**Re: Starbuck's
1000 Rio Grande NW
Request Permanent C.O. - Accepted
Engineer's Stamp dated: 6-17-16 (H13D021)
Certification dated: 9-7-16**

**RE: Starbucks and Burger King, Tract 338-B, 1000 Rio Grande Blvd. SE
Grading and Drainage Plan
Engineer's Stamp Date 6-17-2015 (File: H13-D021)**

**RE: Starbucks and Burger King, Tract 338-B, 1000 Rio Grande Blvd. SE
Grading and Drainage Plan
Engineer's Stamp Date 3-30-2015 (File: H13-D021)**

Based upon the information provided in your submittal received 01-22-15, the above referenced plan cannot be approved for Building Permit until the following comments are addressed:

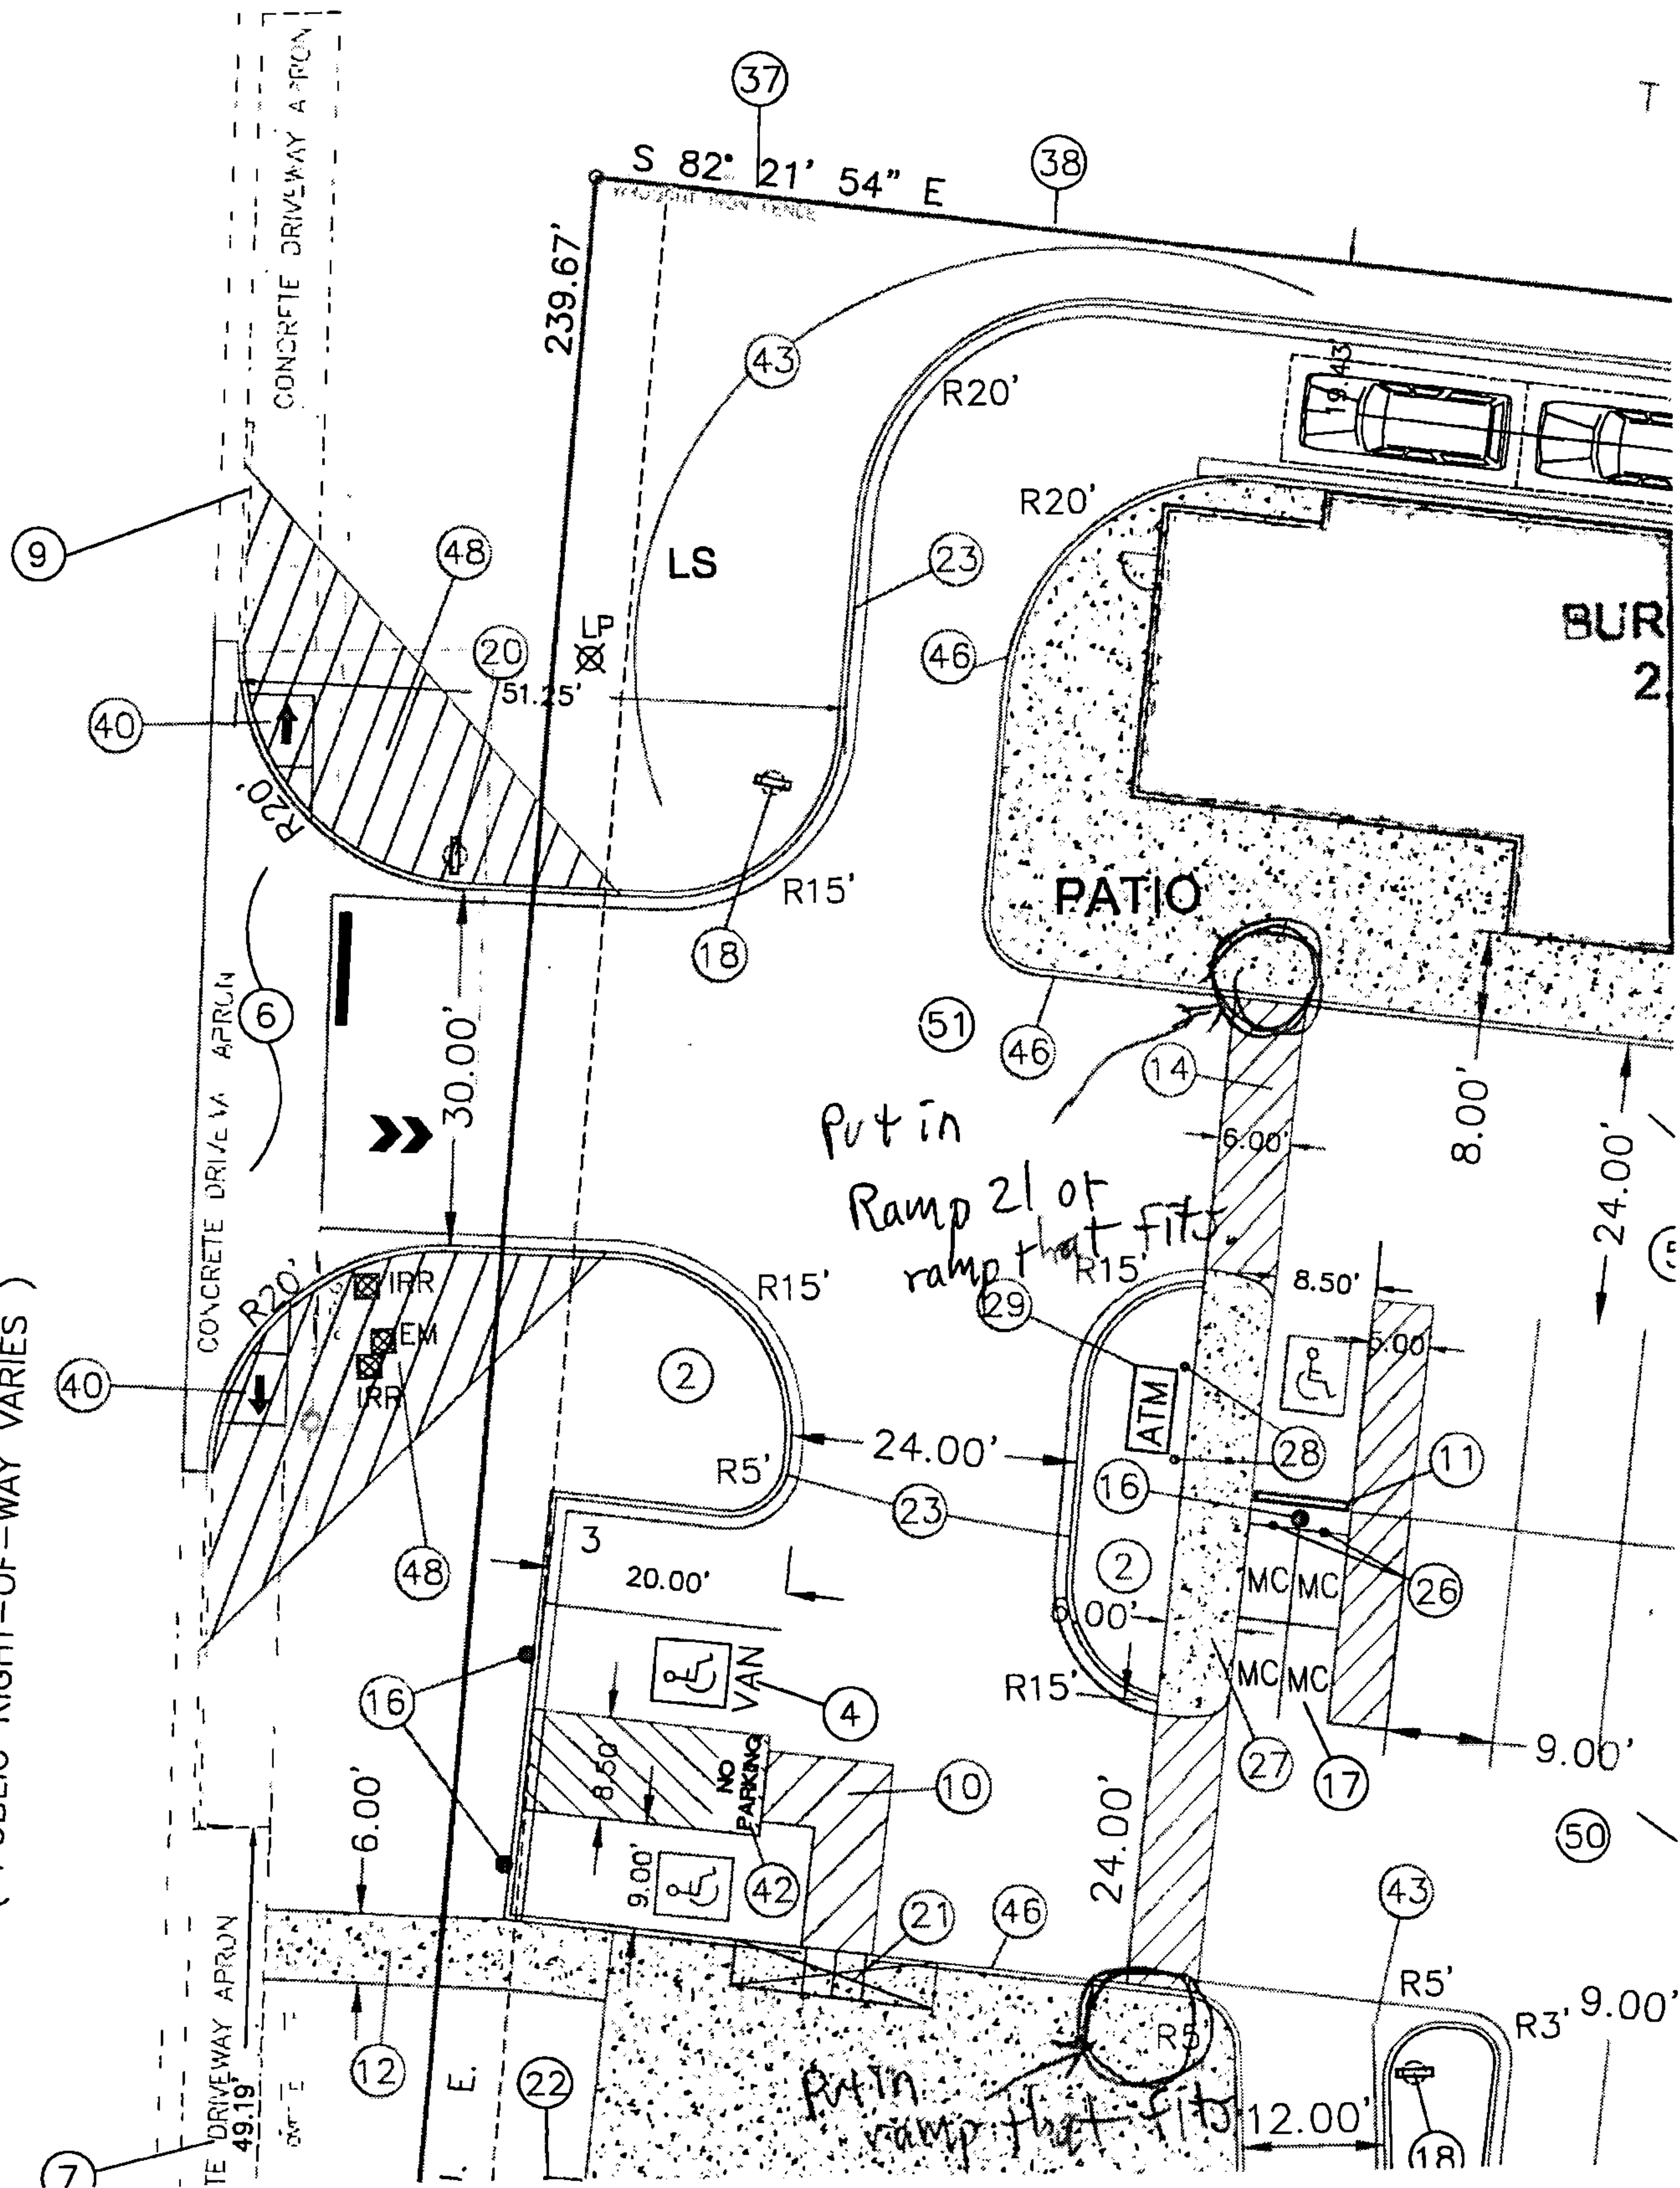
Shawn, as discussed earlier, go ahead and revise the TCL to add a ramp on each end of the pedestrian way from the handicapped spot in the middle of the parking lot (as shown per first attachment).
As per the second attachment, make sure that the curb ramp shows a maximum 2% cross-slope on the ramp.

Return 2 copies of the new TCL and also send an electronic copy. Then, I can approve this.
If you want, you can bring in 4 copies, and I can stamp all 4 copies for you to include the copies for your building permit set.
